**Final Site Plan Review  
For  
City of Northville, Michigan**

<b>Applicant:</b>	156 N. Center, LLC 42300 W. Nine Mile Road Novi, MI 48375
<b>Project Name:</b>	150-156 N. Center St.
<b>Plan Date:</b>	Cover and Architectural Sheets: May 10, 2020 Engineering Sheets: March 17, 2020
<b>Latest Revision:</b>	June 22, 2020 (All sheets have the same date)
<b>Location:</b>	Southeast corner of the N. Center and Dunlap intersection
<b>Zoning:</b>	CBD– Central Business District
<b>Action Requested:</b>	Final Site Plan Approval
<b>Required Information:</b>	As noted within this review

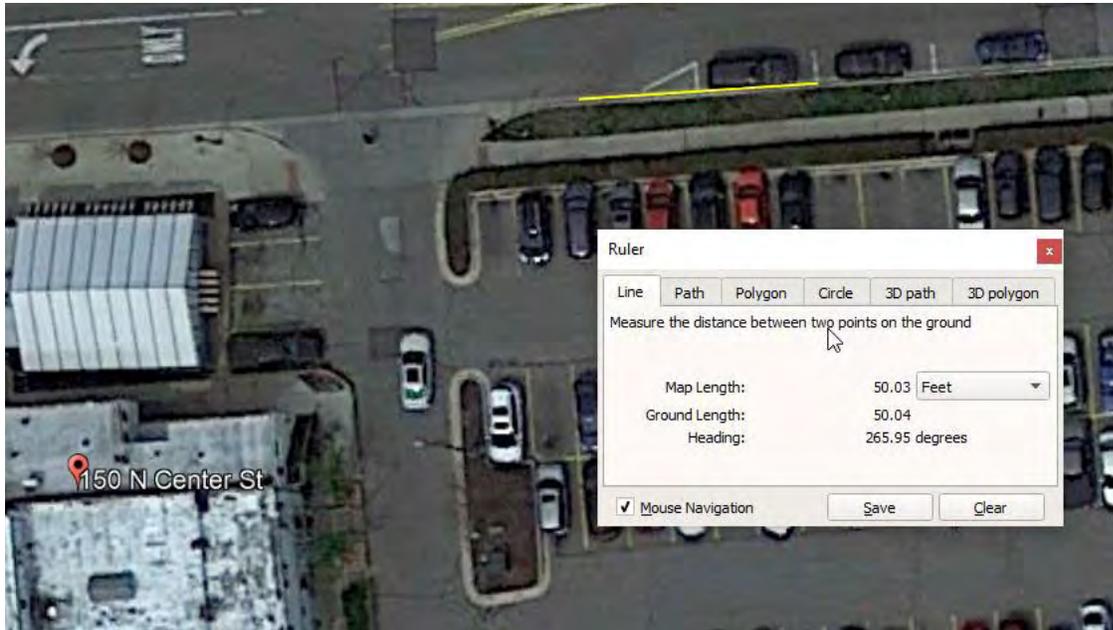
Regarding loading/unloading, the Final Site Plan documents suggested locating this activity directly behind the building, as currently occurs for the Tuscan Café. However, since the time of their submission, the applicants have talked with the City Engineer about this. In response to this discussion, the City Engineer provided a memo (dated July 23, 2020) outlining her assessment, which is included in the Planning Commission packet. She does not recommend maintaining loading/unloading directly behind the building, as it would cause traffic issues to the parking lot driveway. She recommends locating the loading/unloading area on Dunlap St., but to the east of the parking lot driveway. This way, a truck parked at this location will not block any sight lines of cars entering/exiting the parking lot drive. This space could also be reserved for loading/unloading until 10am daily, and then revert to on-street parking for the remainder of the day. This location also eliminates the possibility that parked trucks would block the parking lot driveway or maneuvering lane. The applicant should respond to these recommendations, and how they will ensure trucks use the on-street loading/unloading area. We have included the illustration of the proposed location (shown by the yellow line) from the City Engineer's memo below.

We concur with the City Engineer’s assessment. In our opinion, it meets the Preliminary Site Plan approval condition of not worsening the loading/unloading situation in the area, and is not overly burdensome on the applicant. If agreed to, we would recommend conditioning any Final Site Plan approval on this loading/unloading location.

**Items to be Addressed:** 1. Recommend conditioning any approval on City Council granting 10.8 parking credits to meet the parking requirements for the expanded uses. 2. Applicant to respond to City Engineer’s recommendation for loading/unloading space on Dunlap St. (on the east side of the parking lot driveway), and how they will ensure trucks use the on-street loading/unloading space. 3. Recommend conditioning any approval on locating loading/unloading on Dunlap St., to the east of the parking lot driveway, as illustrated in the City Engineer’s review memo of July 23, 2020.
